Tween Bridge Solar Farm

9.9 Statement of Common Ground with Natural England

Document Reference: 9.9

Revision 2

Figure 1: 16413_P16a_600m Buffers_TLR_RR

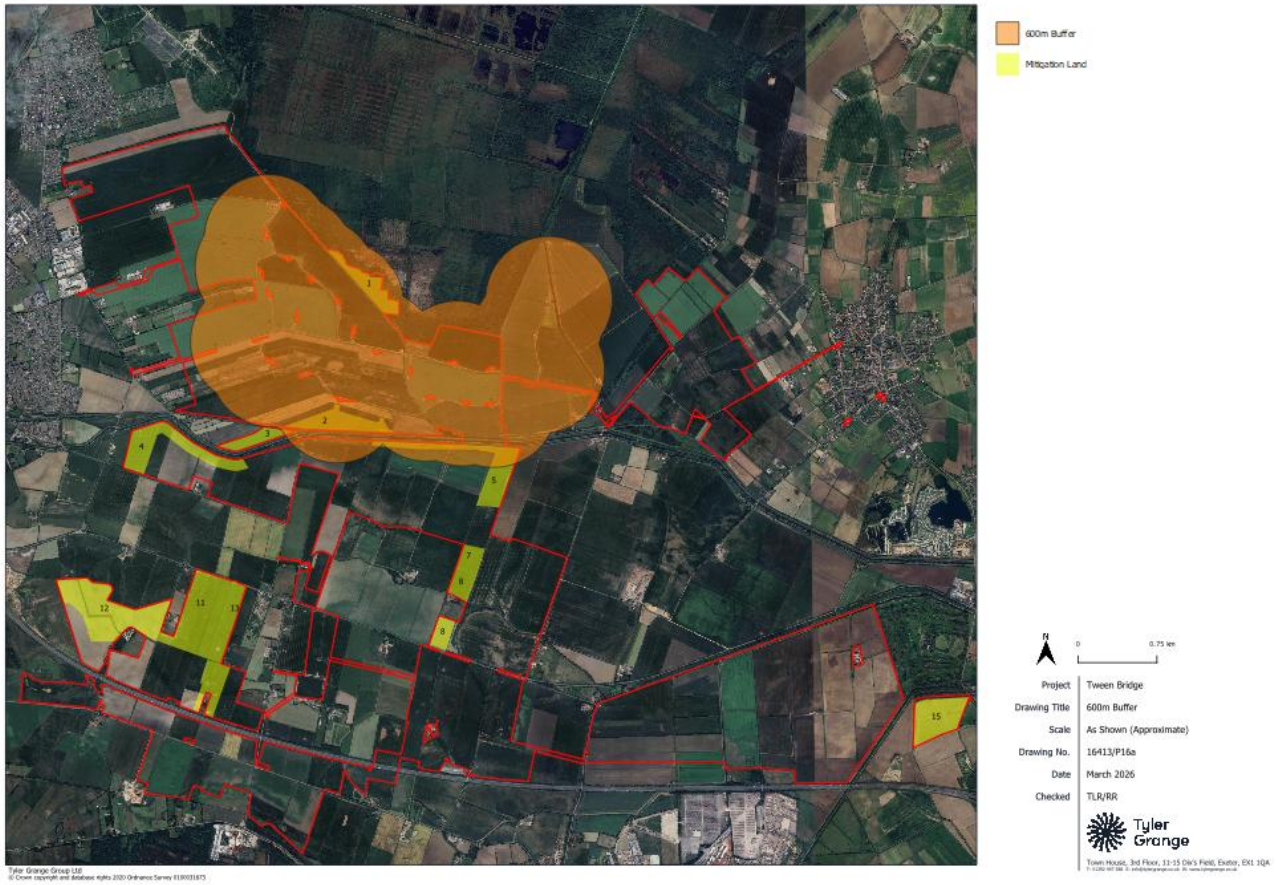
<p>location, and whether this would impact the functionality of the mitigation.</p> <p>Natural England advises that a precautionary buffer of 600m should be used when assessing the predicted extent of displacement from wind turbines. Further assessment should be carried out within the recommended 600 m buffer zone to determine the predicted level and effects of displacement, informed by site-specific factors such as the habitats available, extent and type of bird usage within the buffer zone, relative importance of the area and existing pressures on the species present.</p> <p>Natural England advises that displacing birds on a continuing basis from areas used for all necessary stages of the non-breeding period equates to effective habitat loss, as such habitat is no longer 'available'. Should it be determined that the functionality of the mitigation areas would be adversely impacted, alternative sites should be considered.</p> <p>Cannot locate figure - Please provide further details</p>	<p>email correspondence dated 10.07.2025 – see Appendix 1), and which have been completed in addition to ecological knowledge of the carrying capacity of different habitat types, which is also in line with Natural England’s correspondence when they state that ecological knowledge should supplement the bird days calculations to demonstrate that there is suitable habitat provision for the numbers of birds displaced by the development..</p> <p>The Applicant confirms that Figure:16413_P16a_600m</p>

<p>Report to Inform Habitat Regulations Assessment [Document Reference 5.3 Revision 4] and provided as part of Figure 1 within this document.</p> <p>Several mitigation parcels larger than 10ha with at least 150 m open vistas are provided, including M12 and M13.</p> <p>A total of 43.67ha of mitigation land with 150 m open vistas is located beyond 600 m of wind turbines, in line with point NE3 (see below), and is available for lapwing. Bird Days calculations demonstrate that 24.99 ha is required for lapwing (Appendix 2 of the Report to Inform Habitat Regulations Assessment [Document Reference 5.3 Revision 4]), confirming that more mitigation land is provided than required. Additional mitigation land within 600 m of turbines, including parcels M1 and M2, is also available, and lapwing have been recorded using these areas, therefore ensuring that additional land is available for this species.</p> <p>When considering mitigation land beyond 600 m of turbines, 108.84ha</p>
